ADDENDUM NO. 1

**For: Humble Independent School District
AMS / HMS Additions & Renovations
10203 Birchridge Drive
Humble, TX 77338**

PREPARED BY: PFLUGER ARCHITECTS

ADDENDUM DATE: May 26, 2026

C4.0
DEMOLITION
PLAN

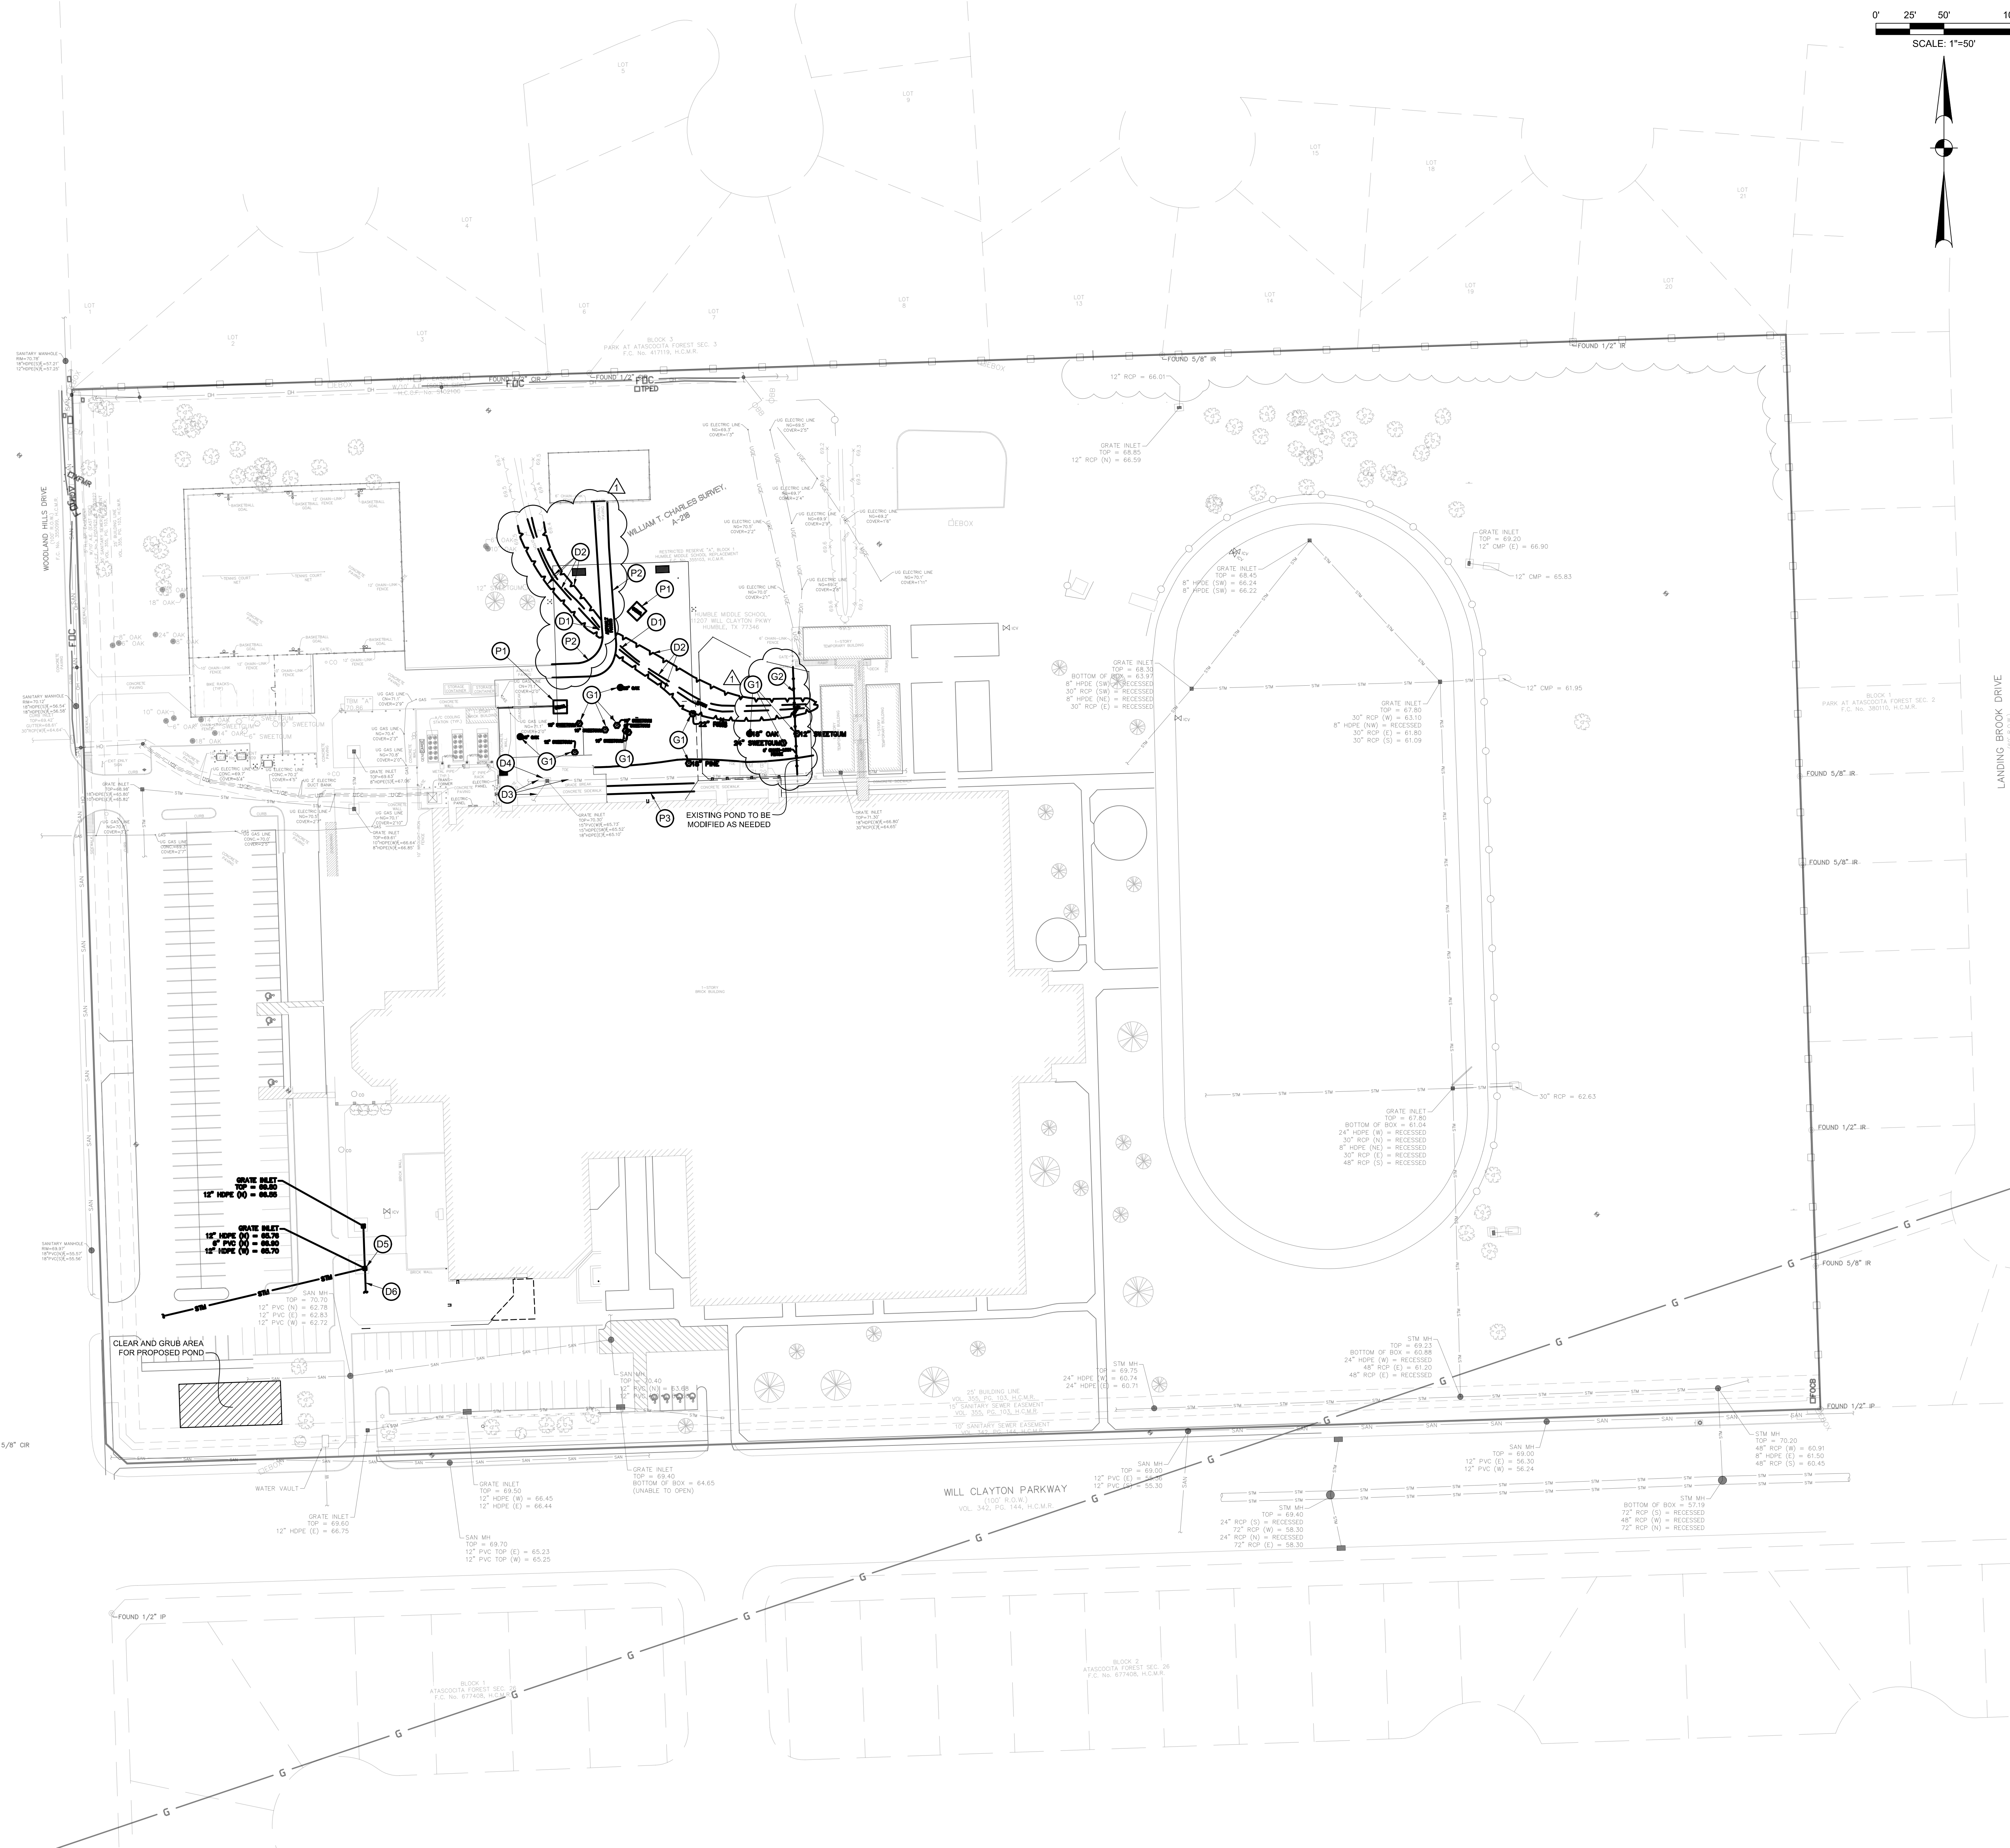
ITEM	SHEET	DESCRIPTION
D1-1	C4.00	Extended the removal of existing swale to be demolished per keynote D2.

D1-2	C4.00	Extended the removal of the existing cell tower drive per keynote P2.
D1-3	C4.00	Added keynote G1 for the removal of three trees within the proposed pond area.
D1-4	C4.00	Added keynote G2 for existing fence to be removed.
D1-5	C5.00	Added layout for new cell tower drive.
D1-6	C6.00	Added paving layout for new cell tower drive.
D1-7	C6.00	Added 6" paving callout to legend.
D1-8	C6.00	Added 6" paving section detail.
D1-9	C7.00	Added layout for new cell tower drive.
D1-10	C8.00	Added layout for new cell tower drive.
D1-11	C8.00	Revised proposed 12" storm line length and flowline between swales.
D1-12	C8.00	Added keynote D7 to connect proposed canopy drain to proposed storm manhole.
D1-13	C8.00	Added note for restrictor pipe at pond outfall.
D1-14	C9.00	Added grading for new cell tower drive layout.
D1-15	C9.00	Added swale near new cell tower drive.
D1-16	C9.00	Revised proposed north pond FL and design WSEL.

ISSUED FOR CONSTRUCTION
C9.0
GRADING PLAN

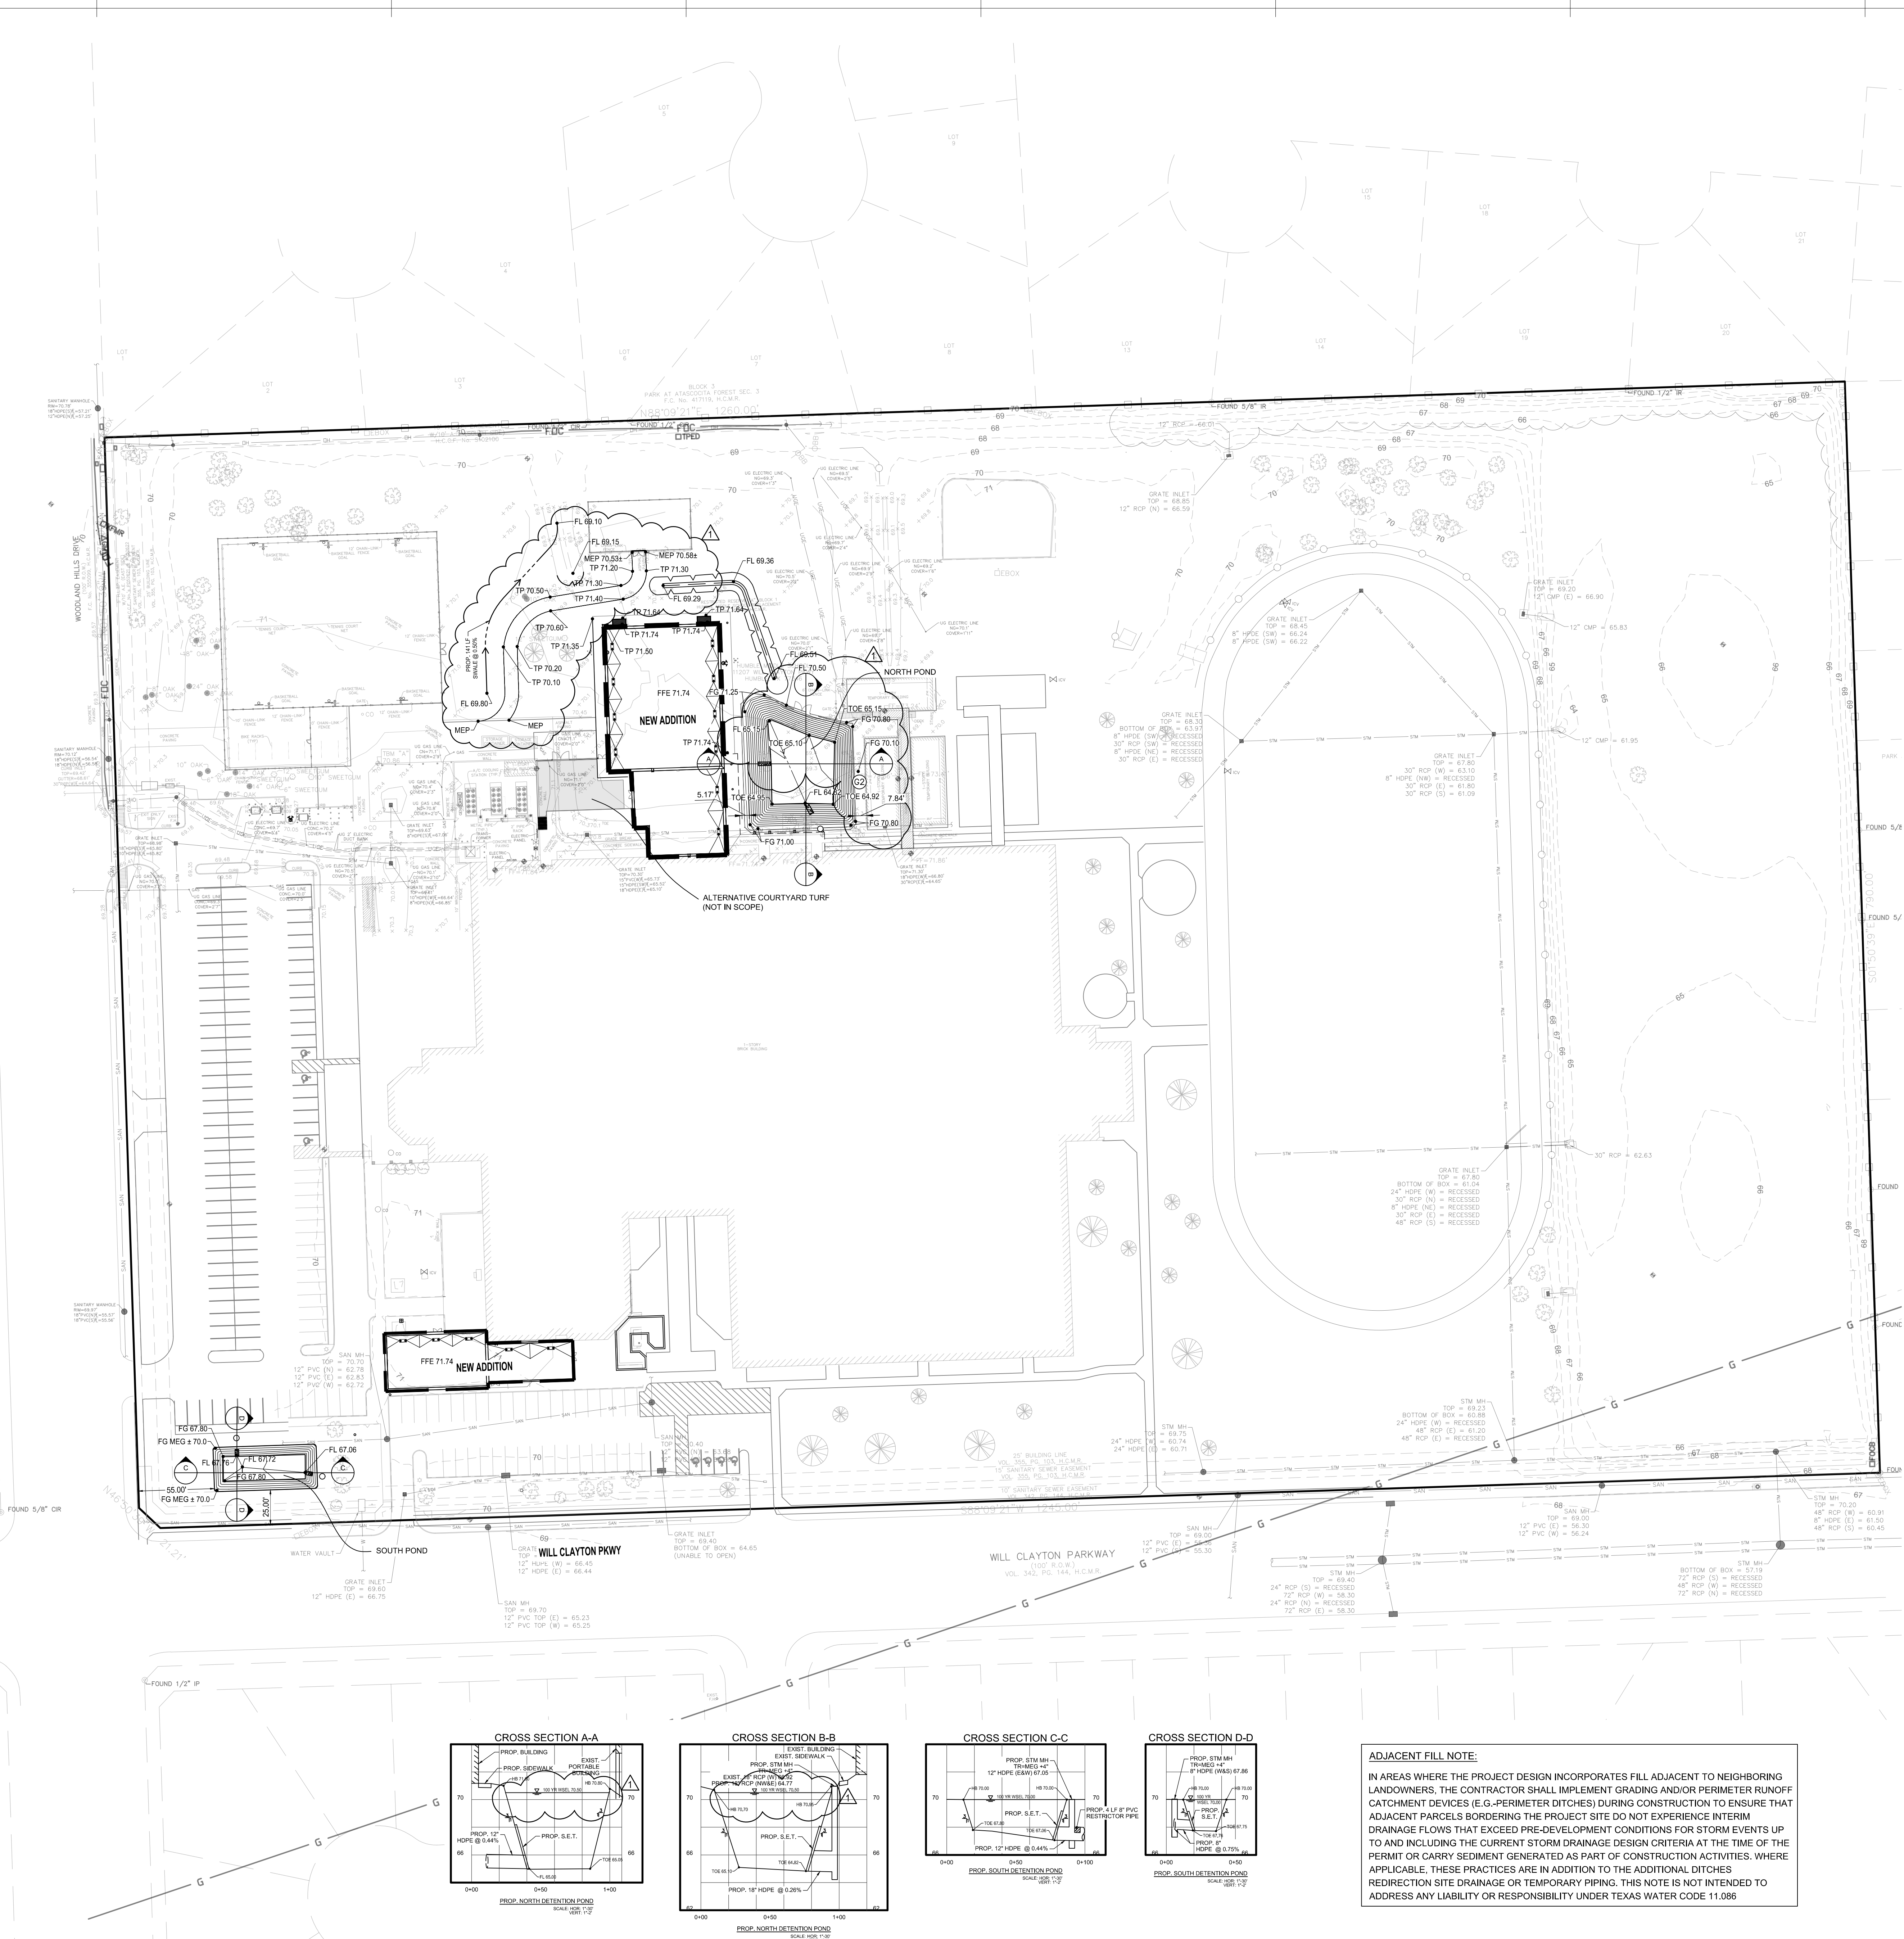
D1-17	C9.00	Revised proposed pond stage storage table.
D1-18	C9.00	Added keynote G2 for contractor to grade for positive drainage near north pond.
D1-19	C10.00	Added drainage flow arrows near new cell tower drive layout.
D1-20	C10.00	Updated impervious cover calculations.
D1-21	C10.00	Updated detention summary calculations.
D1-22	C10.00	Updated restrictor calculations.
D1-23	C11.00	Revised proposed filter fabric fence layout.
